TOWN OF ERIE POLICE DEPARTMENT ADDITION & RENOVATION

SITE PLAN

TOWN OF ERIE
ERIE PD - ADDITION & RENOVATION
1000 TELLEEN AVENUE, ERIE, COLORADO 80516
COVER SHEET

SHEET IDENTIFICATION
C-405

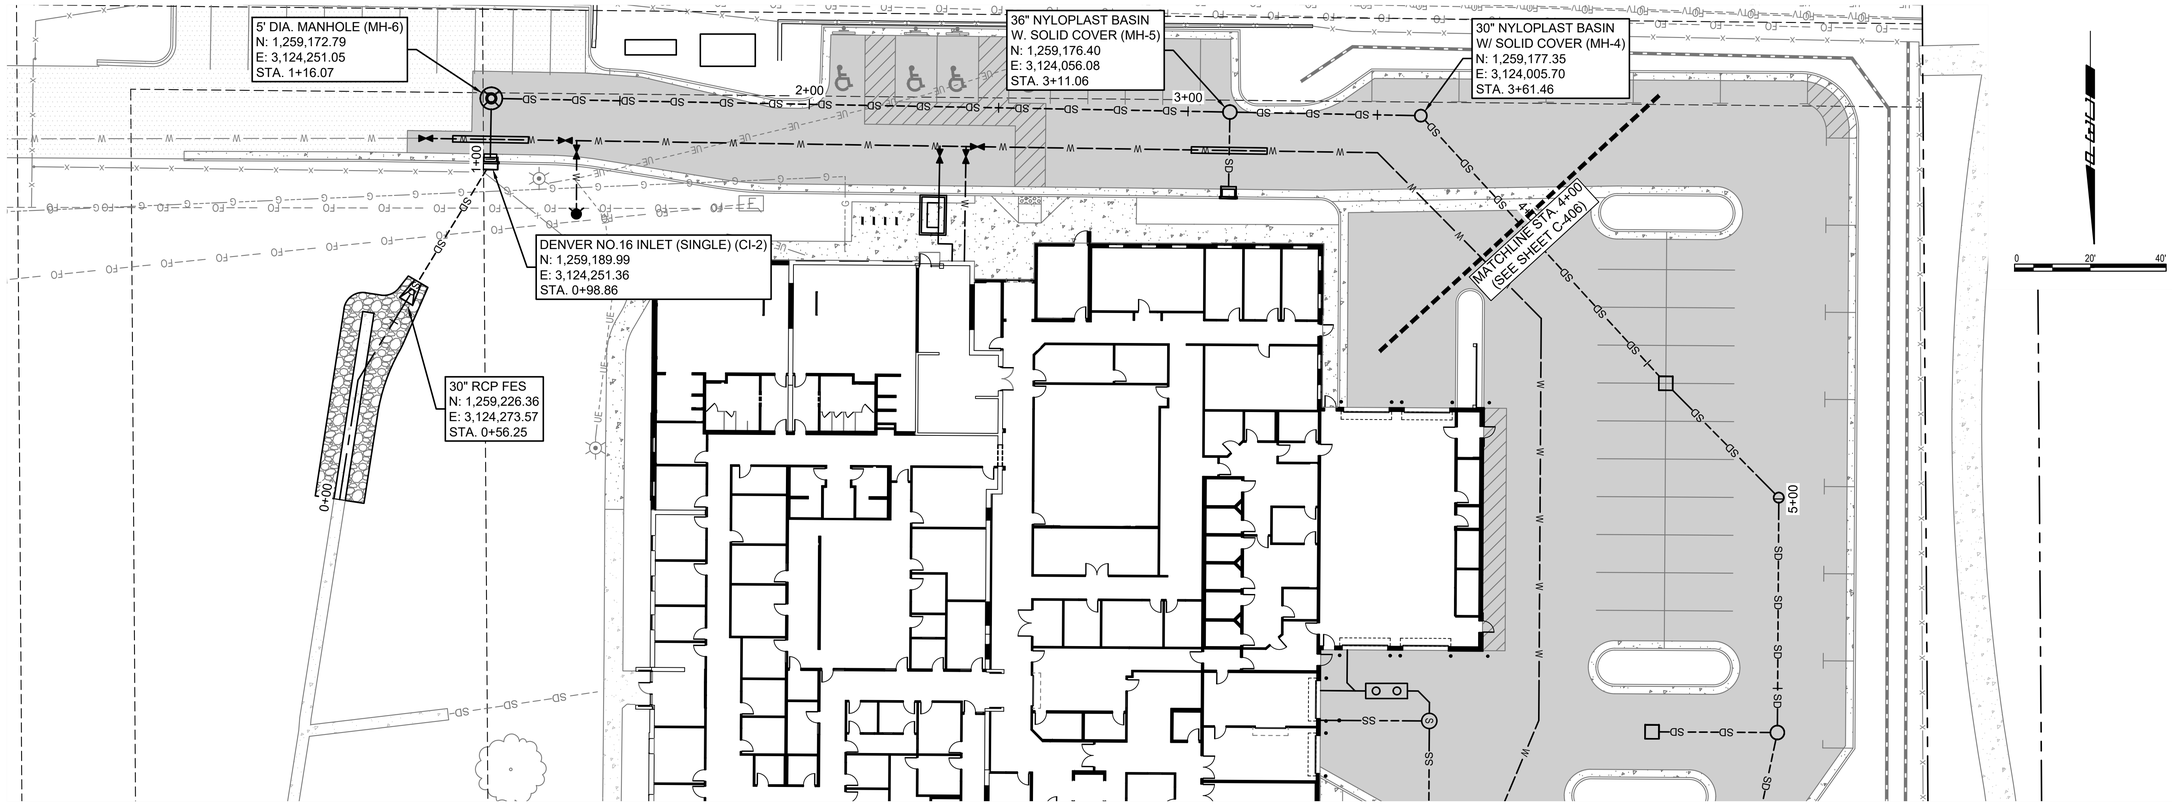
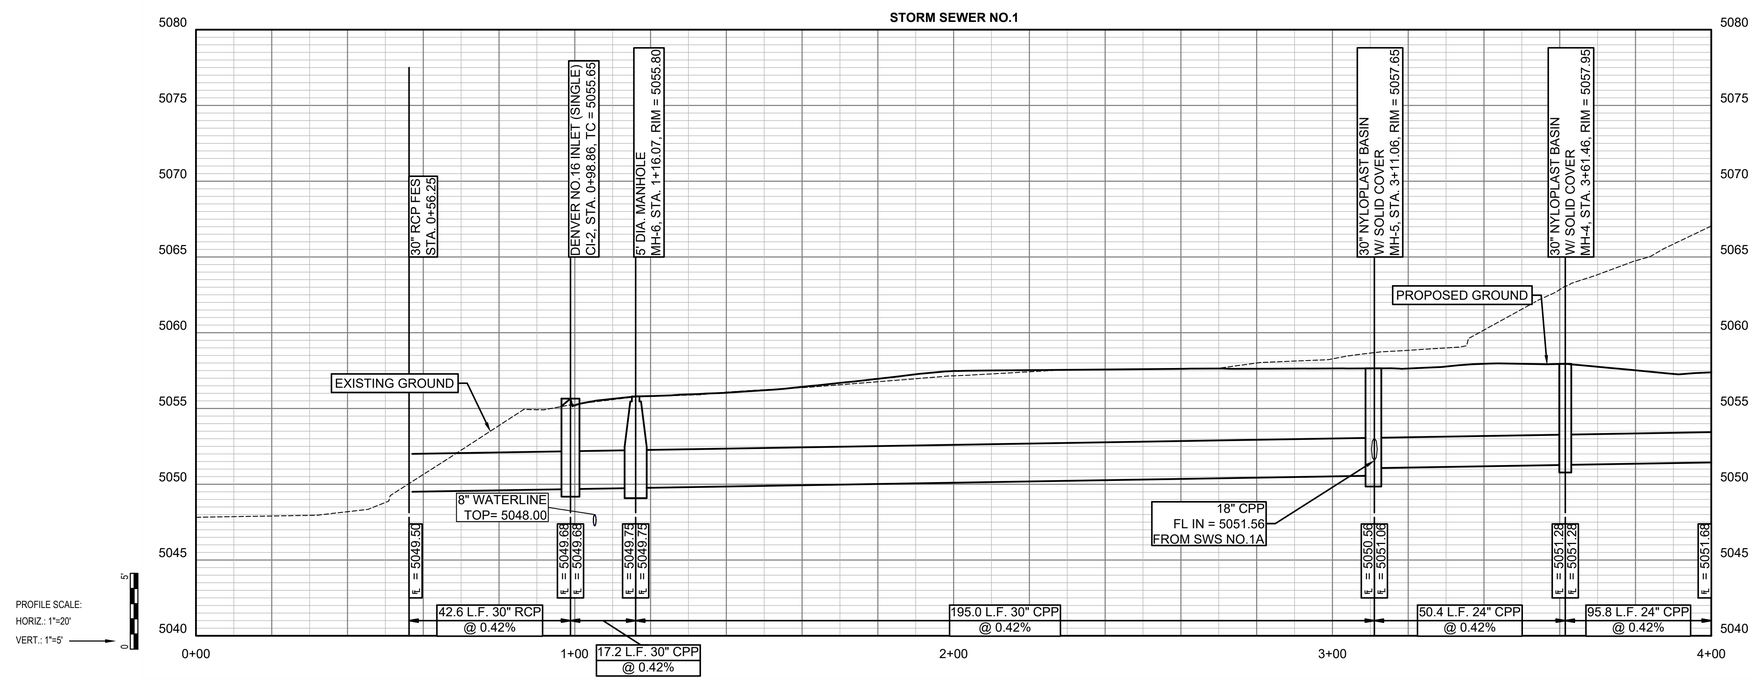
9. On Sheet C-405, 30" CPP at 0.42% slope is proposed. We suggest using RCP for storm pipes greater than 24" diameter, especially when installed at a relatively flat slope as proposed.

12. On Sheets C-405, C-406, andC-407, show the hydraulic grade line (HGL) from the SewerGEMs analysis on the profiles.
13. On Sheets C-101, C-102, and C-201 include the existing trees shown on Sheet LP402 near the south end of the detention pond. On Sheet C-102 show tree removal, if needed.

1. On sheet C-405, please:
   a. Include a toe wall at the invert of the pipe to frost depth per MHFD criteria Vol 2, Fig 9-29 through 9-33.
   b. Show the forebay in the profile with the concrete pan.
   c. Confirm that the existing concrete pan will tie into the corner of the forebay. It is best if the concrete pan ties into the middle of the forebay near the notch to convey stormwater to the outlet structure. See also comment number 6 of General Stormwater Report Comments
2. MHFD is curious for the need of a riprap rundown and a baffle wall in the forebay. Please expand on the discharge velocity of the pipe based on Appendix F and the need for additional outlet protection outside of the forebay.
3. On sheet C-416, please:

a. All storm sewer pipes have been revised to RCP.
10. On Sheets C-406 and C-408, at Inlets CB-1 and CB-2 provide minimum 24" cover for HDPE pipe (Section 815.03).

C1 | SDP BUILDING ELEVATION - EAST

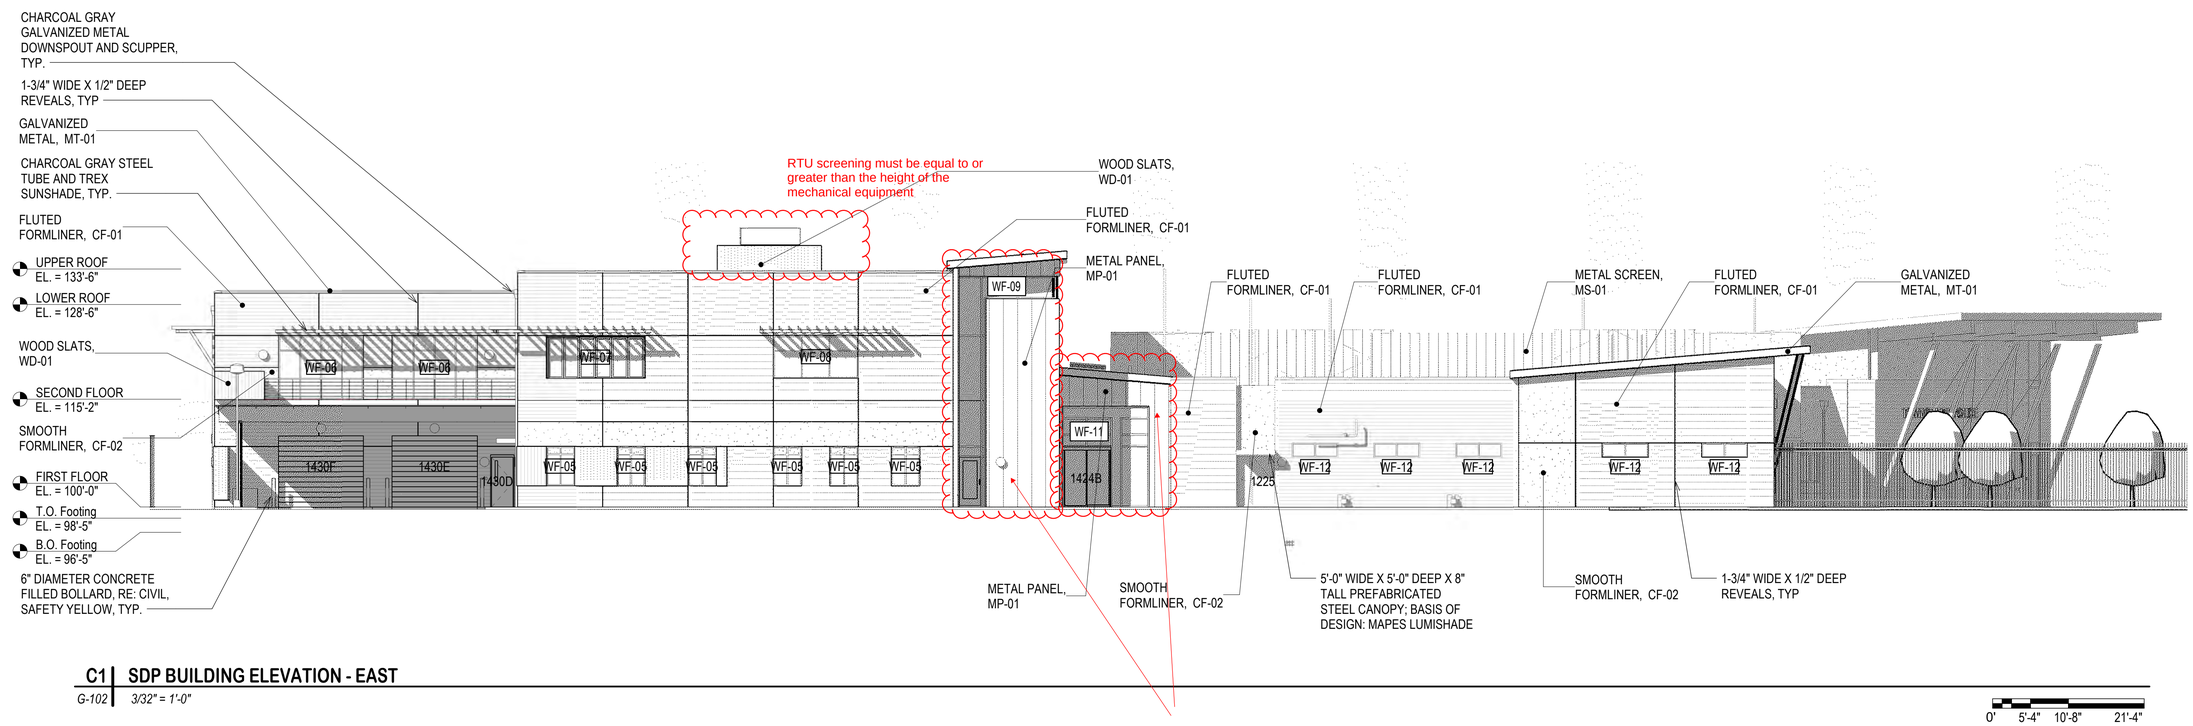
No more than 25 percent of each façade of the building shall be finished with metal material. Metal materials used shall be compatible with the historic character of the DT and NMU Old Town district. **Note - it looks like these elevations are under 25%, we wouldn't count canopies, trim, RTU screening, garage doors etc., it's just calculating where there is actually metal cladding

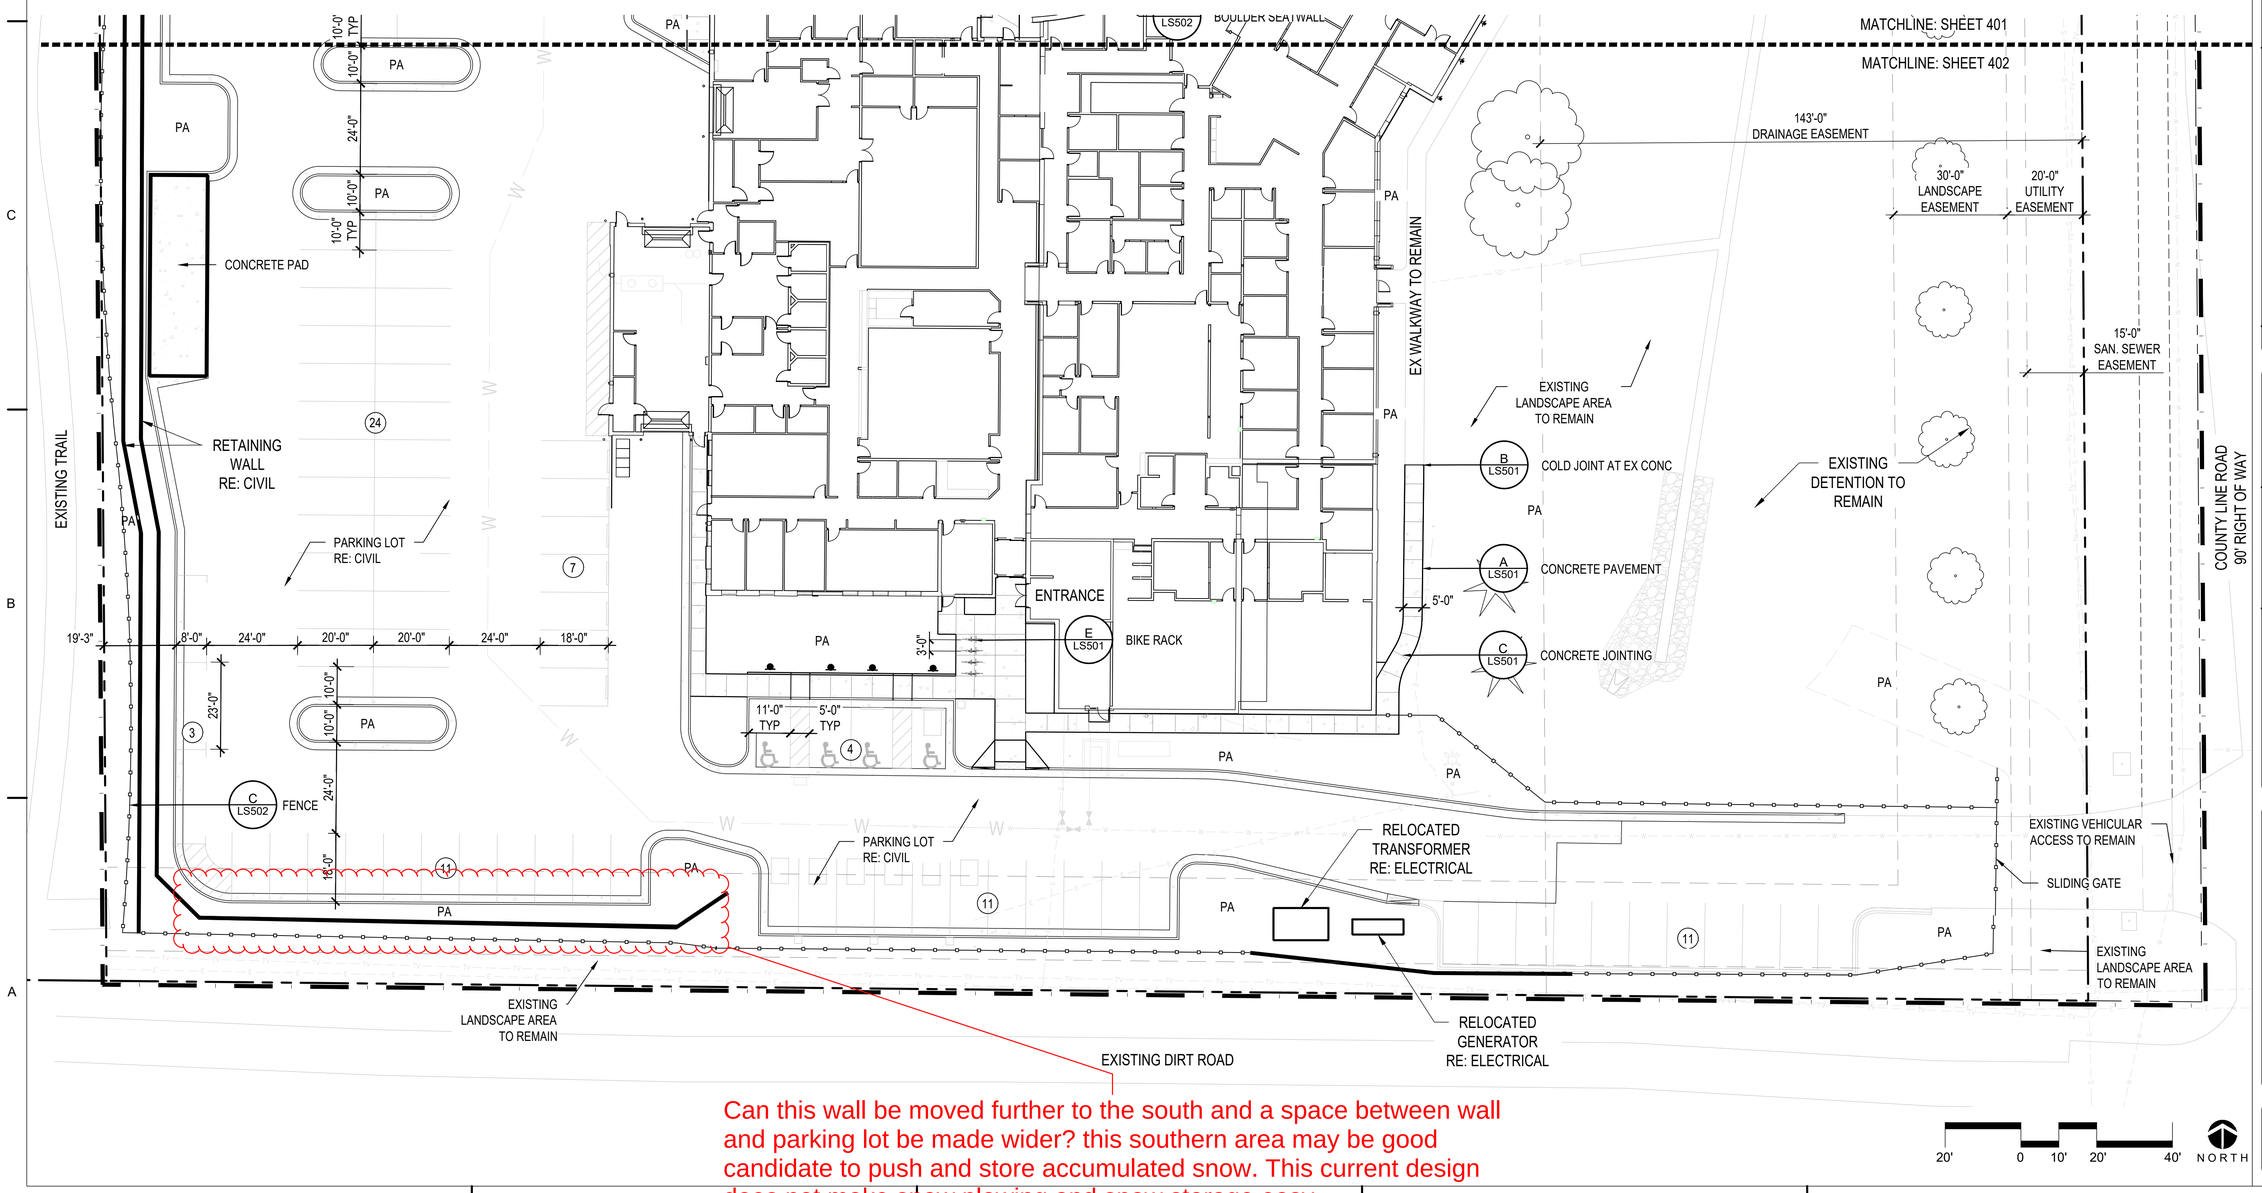
Can this wall be moved further to the south and a space between wall and parking lot be made wider? this southern area may be good candidate to push and store accumulated snow. This current design does not make snow plowing and snow storage easy.

C1 | SDP BUILDING ELEVATION - EAST

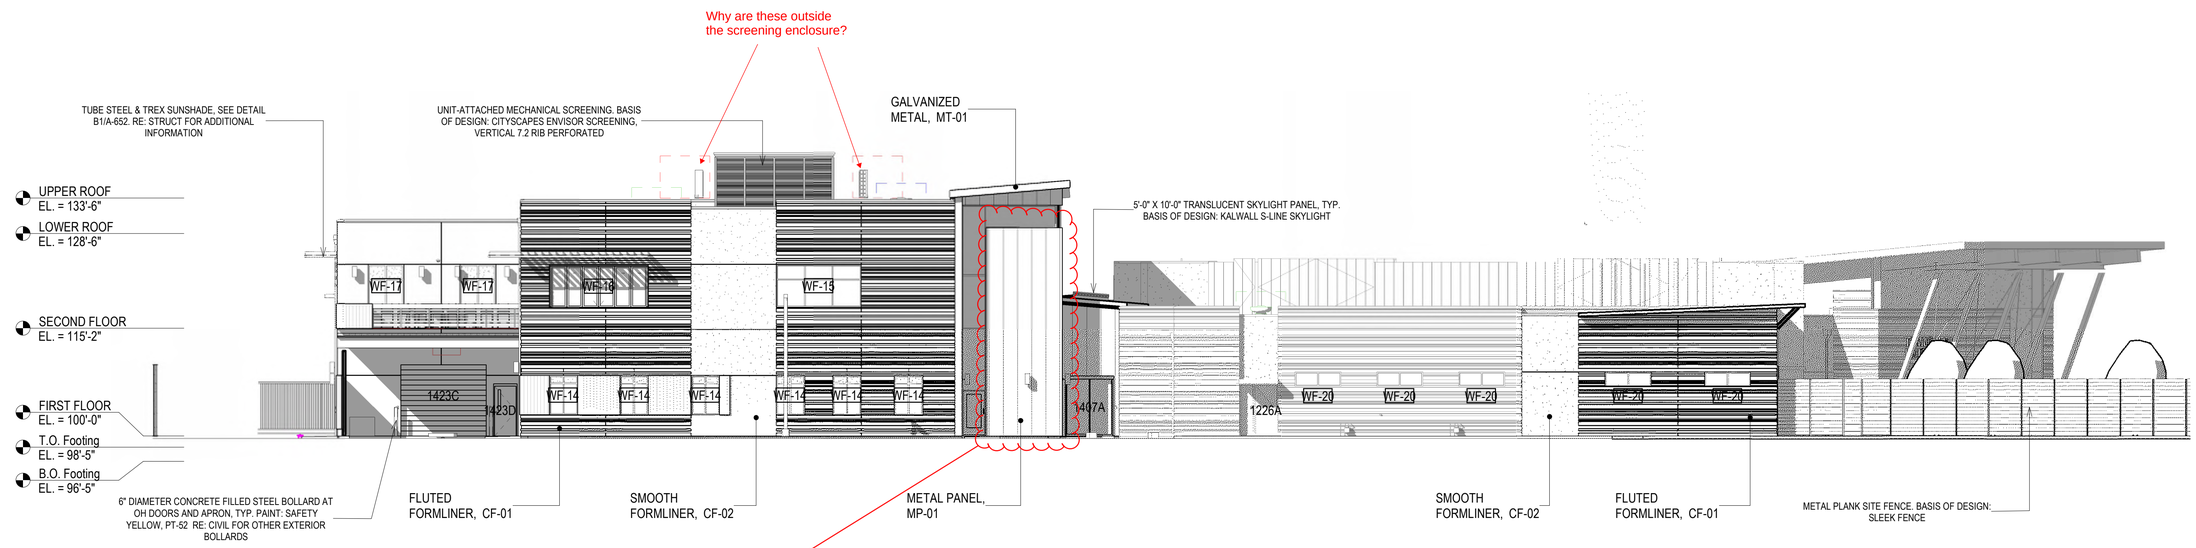
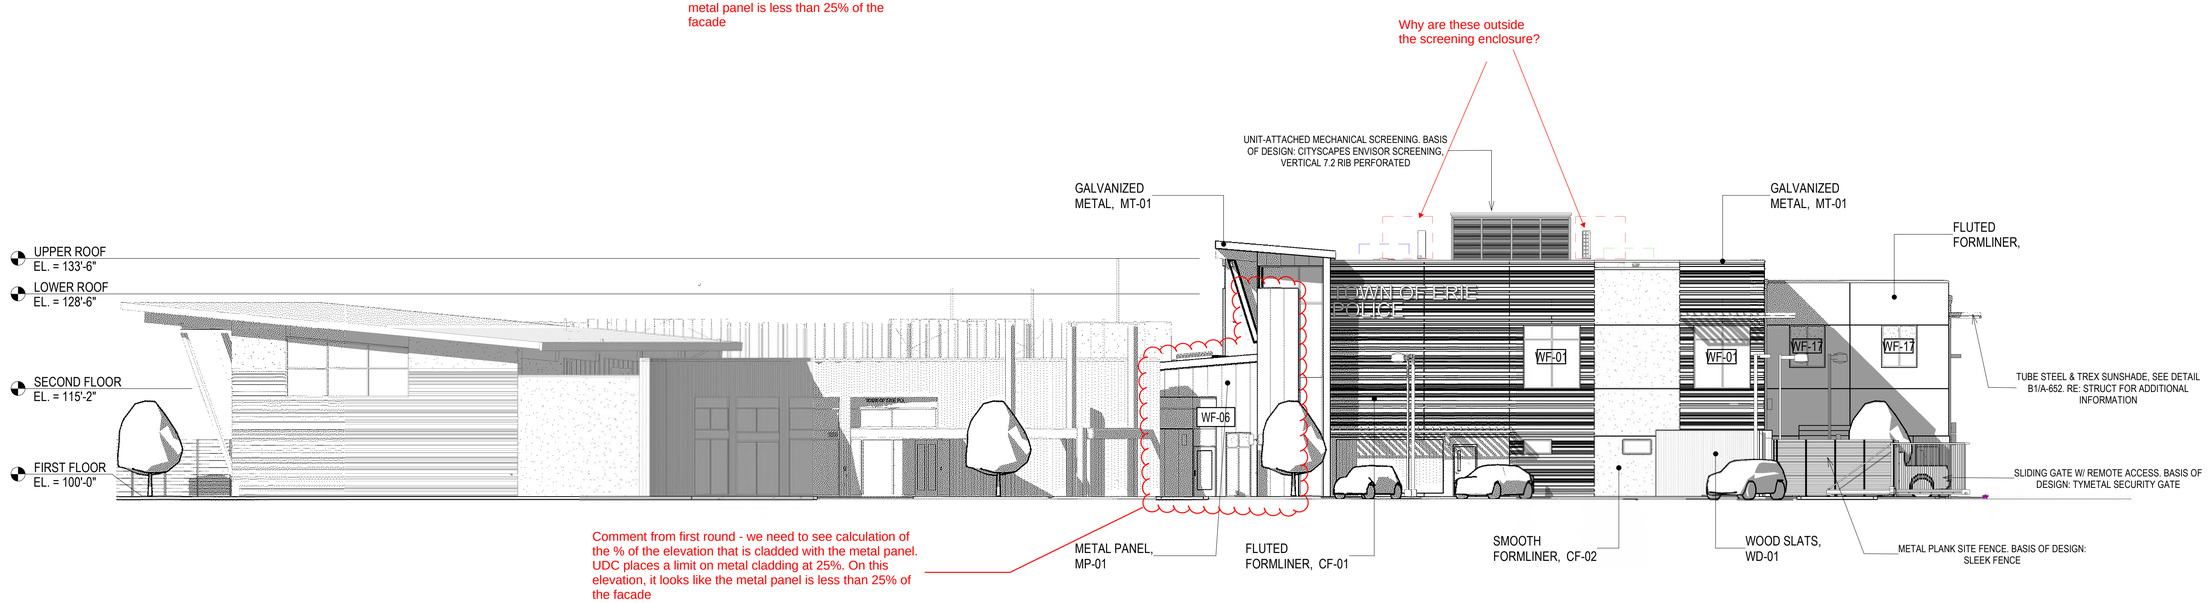
Comment from first round - we need to see calculation of the % of the elevation that is cladded with the metal panel. UDC places a limit on metal cladding at 25%. On this elevation, it looks like the metal panel is less than 25% of the facade

Comment from first round - we need to see calculation of the % of the elevation that is cladded with the metal panel. UDC places a limit on metal cladding at 25%. On this elevation, it looks like the metal panel is less than 25% of the facade
